MANDATORY SERVICE BULLETIN**NUMBER:** SB-024**REVISION:** 03**DATE:** 12/04/2012**SUBJECT:** MANDATORY GARMIN G1000 SOFTWARE UPGRADE TO GDU VERSION 10.01

- All KODIAK 100 Series Aircraft currently using GARMIN 9.03 software. System Software Version 0552.04 will be displayed in the upper right corner of the MFD splash screen.

Quest is mandating an upgrade to the current GARMIN G1000 operational system software. This upgrade will bring the GDU operational software level up to version 10.01. The new software includes many improvements to the operating system and also redefines the Autopilot Annunciation in the G1000 software which is mandated by the FAA. The update must be performed by Quest Aircraft LLC. or by a GARMIN Authorized Service Center who can access and load the new software required to comply with this Service Bulletin. The new software can be obtained through the GARMIN web site using the procedures defined in this Service Bulletin.

1.8 REMOVE AUTOPILOT PLACARD

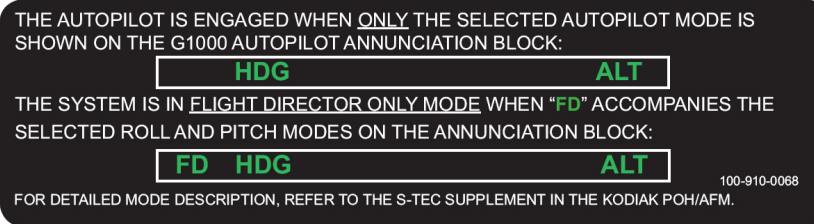
After the update is finished, the autopilot placard (P/N 100-910-0068) located on the right side of the S-TEC autopilot must be removed. See image below:
